ALAMEDA COUNTY  
HEALTH CARE SERVICES

Subject: Fuel Leak Case No. R00000142, Vogue Tyres, 240 W. MacArthur Blvd.,  
Oakland, CA 94611

Subject: Workplan for Additional Site Characterization  
Oakland Auto Works (Former Vogue Tyres) – 240 W. MacArthur Blvd., Oakland, CA  
ACEH Fuel Leak Case No. R00000142

Subject: Amended Workplan for Additional Site Characterization  
Oakland Auto Works (Former Vogue Tyres) – 240 W. MacArthur Blvd., Oakland, CA  
ACEH Fuel Leak Case No. R00000142

**SITE PLAN WITH HISTORICAL AND PROPOSED SAMPLING LOCATIONS**

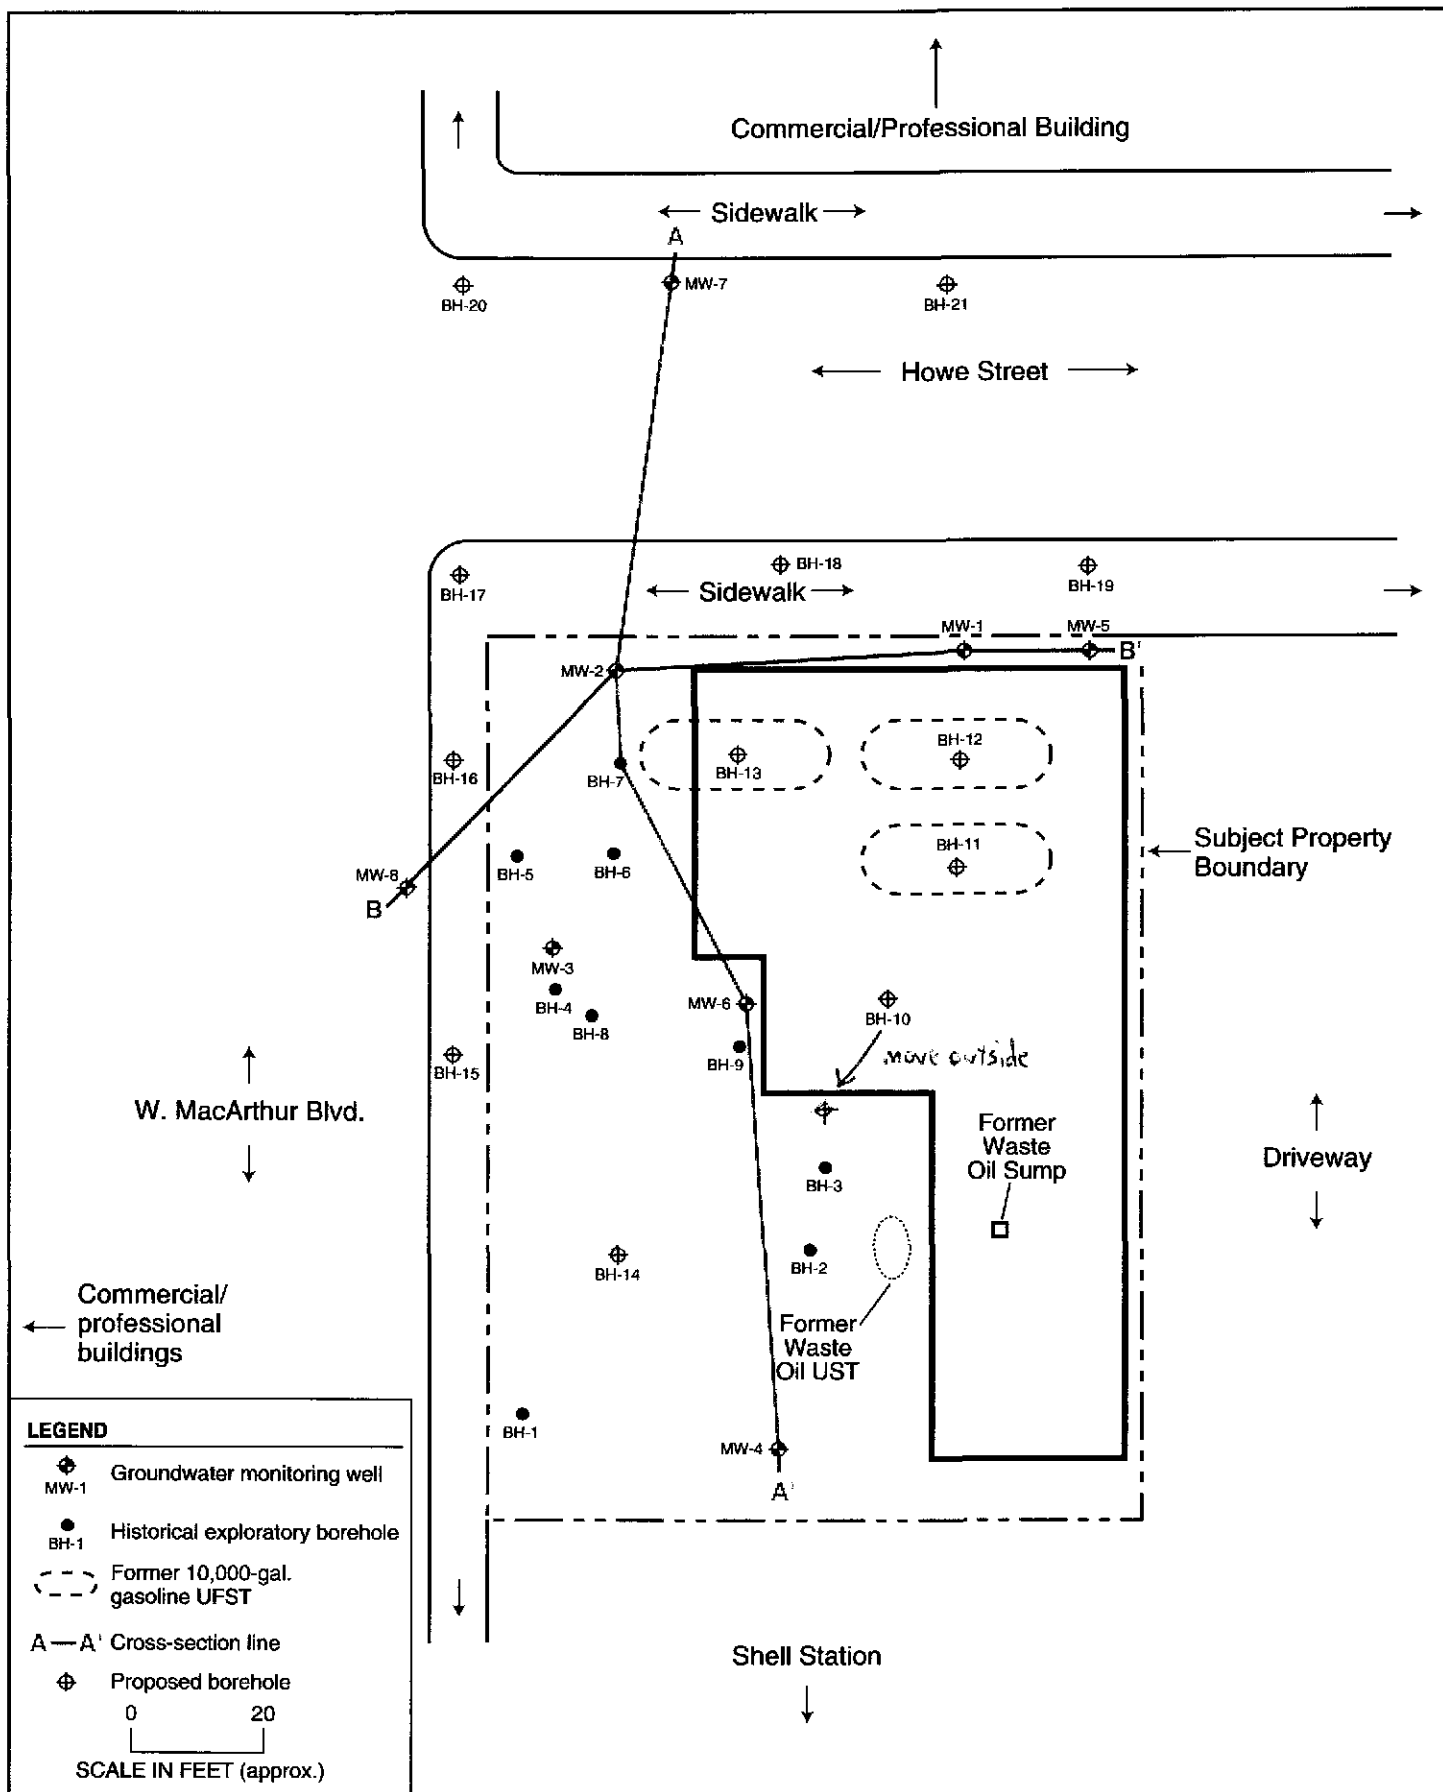
- 1) Site Characterization – The Workplan proposes boreholes to define the groundwater contaminant plume. We do not agree with the three proposed boring locations east of the property because the groundwater flow has been indicated west and north. Instead, we believe that to define the plume, additional boreholes ought to be located west of the former fuel tanks and boreholes BH-6 and BH-4, and north of the former fuel tanks and MW-1 and MW-5 on the site side of Howe St. Please propose additional sampling locations to define the plume associated with your site in the amended work plan requested below.

The ACEH requested that the three originally-proposed boreholes to the east of the property be eliminated, and that additional boreholes be placed to the west and to the north of the former UFSTs. Our revised, proposed borehole locations are shown on the attached figure. We are proposing a total of 12 boreholes, focused on the north and west sides of the plume, and in the area of the former UFSTs.

- 12 boreholes including 3 in the former UFST source area and 9 outboard (see figure), to north, west and south
- Continuous core soil sampling and geologic logging
- Lab analysis sample soil sampling on 5-foot depth intervals (unless otherwise dictated by PID readings, lithology changes, saturation changes, etc.)
- Grab-groundwater sampling
- Lab analyses (see spreadsheet)
- Evaluation of the lower "aquitar" zone

**Figure 3**  
by: MJC      FEBRUARY 2004

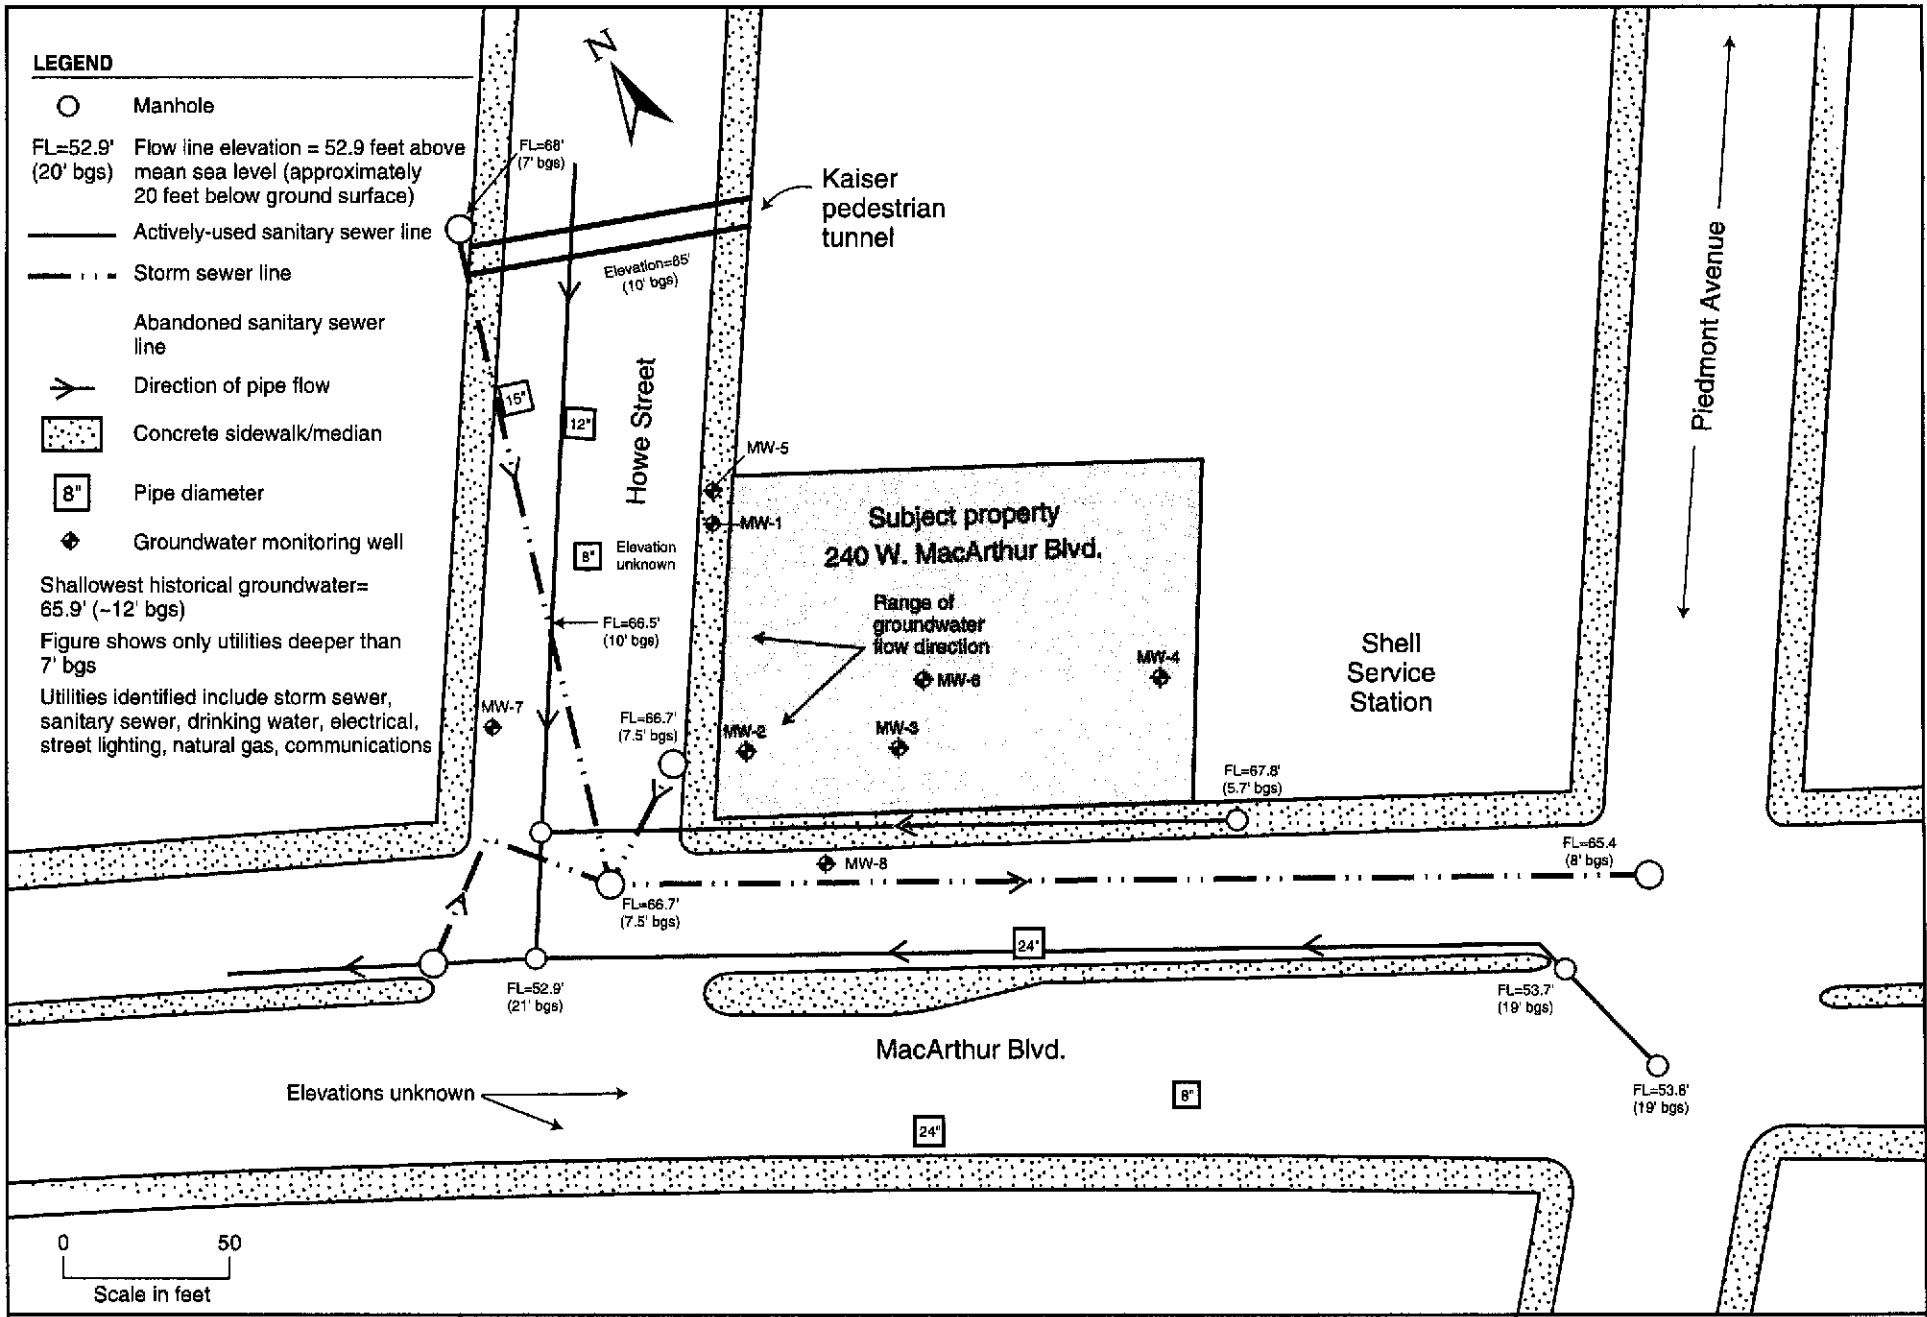
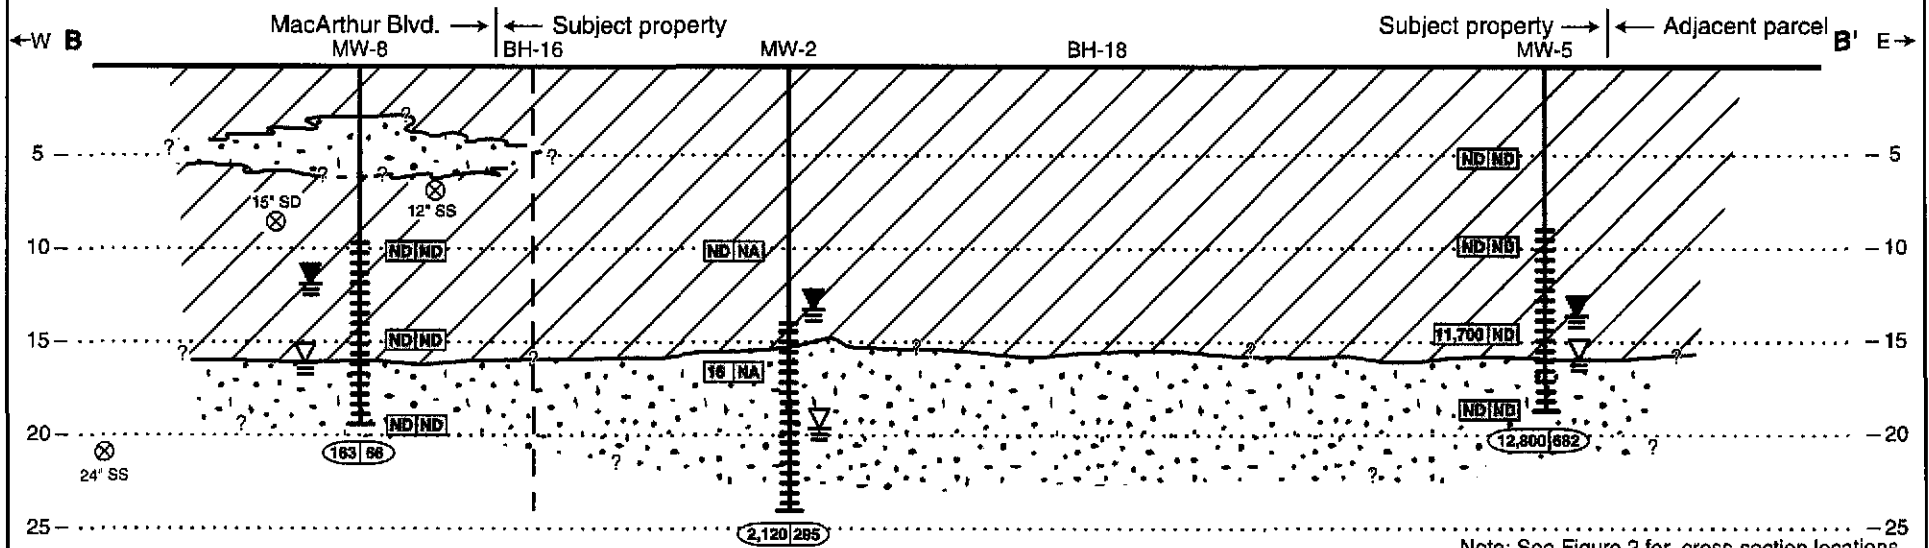
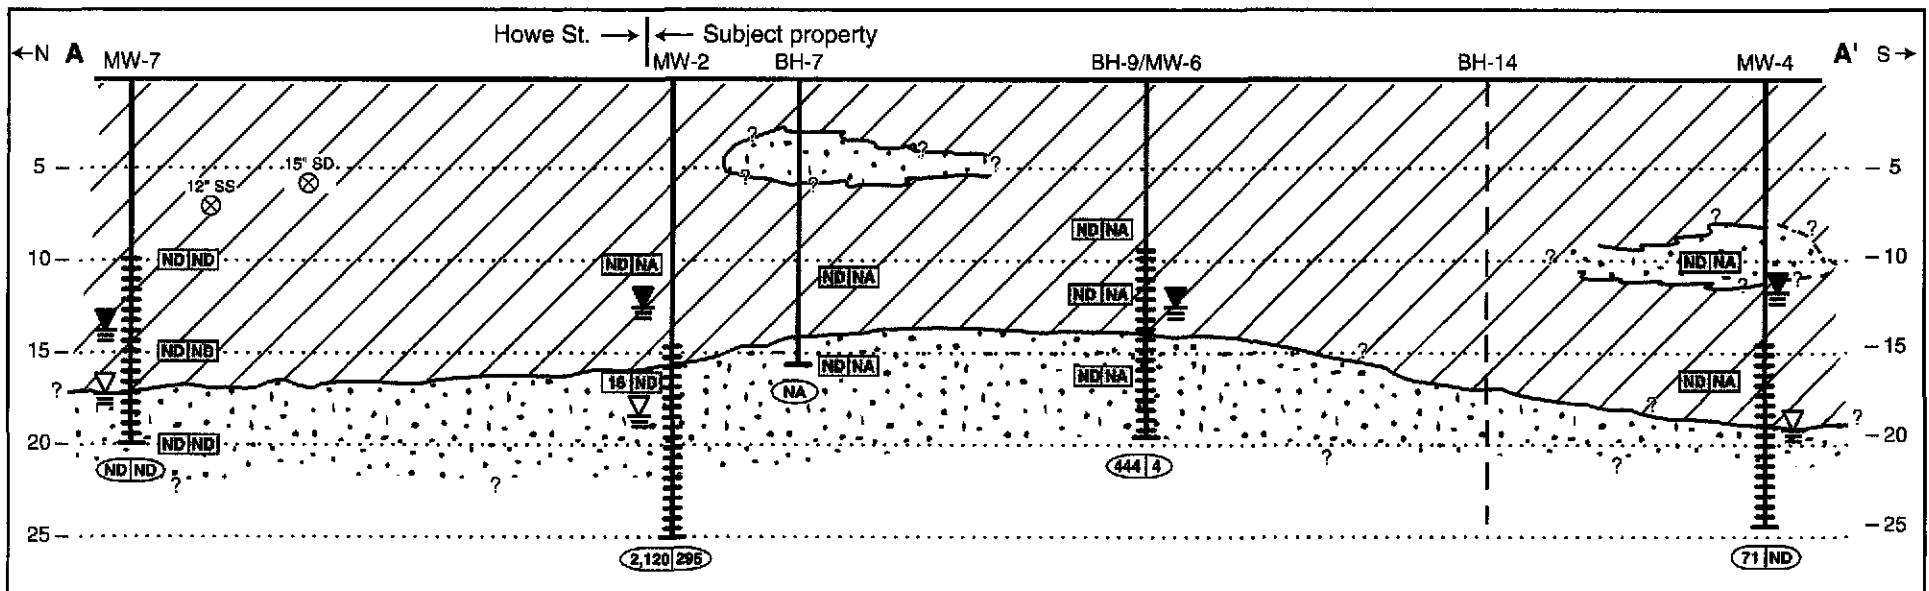
- 4) Geologic cross-sections – A-A' and B-B' were provided. Please show their locations on the site plan. In your cross-sections, please also include soil and groundwater analytical results, and utility conduits. Please use cross-sections to propose additional boreholes, evaluate the probability of the contaminant plumes encountering preferential pathways and the occurrence and distribution of MTBE at your site in the Soil and Water Investigation Report.

- 4) Geologic cross-sections – Please also provide a length wide cross-section of the property.

Per ACEH request, attached is the amended site plan showing the site cross-section locations. The cross-sections for the Soil and Water Investigation Report will be amended to include the findings of the proposed investigation, including soil and groundwater analytical results and utility conduits. The cross-sections will be used in the Report to evaluate the probability of the plume encountering preferential pathways.
